Subject ▶ Discontinuance of strain relief (concave type)

For Models ▶ 9027, 9027S, 9029, 9029S, 9037, 9037S, 9039 and 9039S (Disc Grinder)

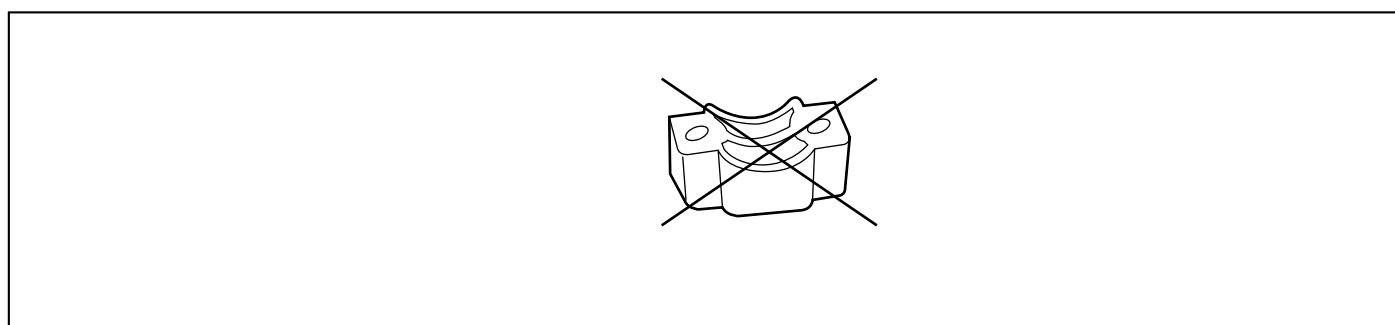
1. The handle (L) will have a strain relief molded into it.

The handles (L) and (R) will have walls to prevent dust from entering the tool.

2. The strain relief (concave type) will be discontinued.

3. The tapping screw will be changed as follows.

Item No.	Current part		Q'ty	I/C	New part		Q'ty	Note
36	Handle set 182563-9		1	No	Handle set 182607-5		1	
41	Strain relief (concave type) 687051-6		1					
43	Tapping screw BT4x18 265941-9		2	No	Tapping screw PT4x18 265995-6		2

The current type parts and the new type parts are interchangeable as a set.
